MassDOT Parcel 25/26 Community Questions and Comments sorted by major theme:

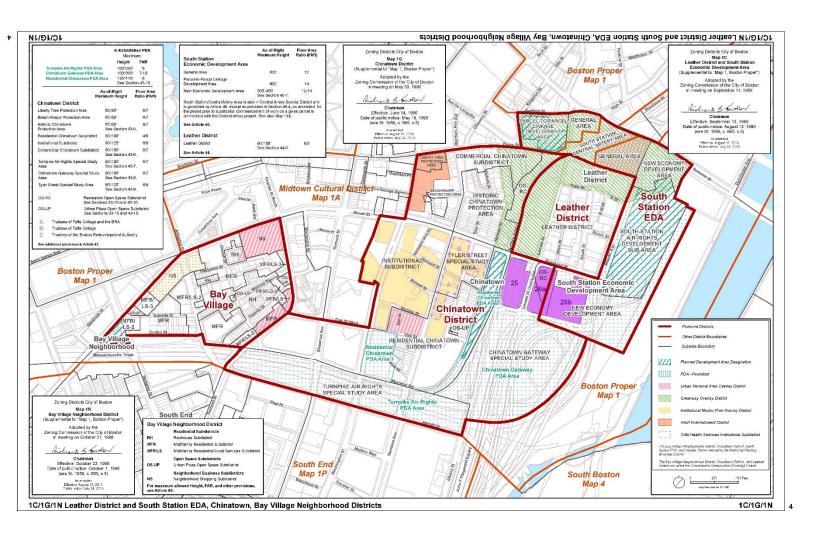
Question/Concern: What is the current zoning, including height, setback, and FAR for the site? Will heights and density along Kneeland street be lower, with increasing heights and density as one goes South on the site? Will a shadow study be conducted?

**Response**: The site includes multiple zoning districts. It is both within the Chinatown District and the South Station EDA (Economic Development Area).

Parcels 25 and 26a are within the Chinatown District's "Chinatown Gateway Special Study Area/Chinatown Gateway PDA Area". A portion of parcel 26a is also zoned OS-RC within the Chinatown District. Parcel 26b is within the South Station EDA's "New Economy Development Area".

Within the Chinatown Gateway Special Study Area, if a proposed project undergoes Article 80/Large Project Review, a Floor Area Ratio (FAR) of 6.0 and a maximum height of 100 feet are permitted as of right (see Article 43 of the Zoning Code and Table E for a complete listing of allowed, conditional, and forbidden uses). The maximum height and FAR can be increased up to 300 feet and 10.0 if the development is designated an approved PDA.\*

Within the New Economy Development Area, a proposed project is allowed an as-of-right building height of 300 feet and an as-of-right FAR of 12; and any other Proposed Project shall have an as-of-right building height of 400 feet and FAR of 14 as determined under Section 40-8(2) if a Development Plan for such Proposed Project has been approved pursuant to Section 3-1A.a and Planned Development Area Review.

Shadow studies can be required as part of the PDA and Article 80 processes. Heights will, at a minimum, be limited to 125' for a depth of 50' along Kneeland Street.
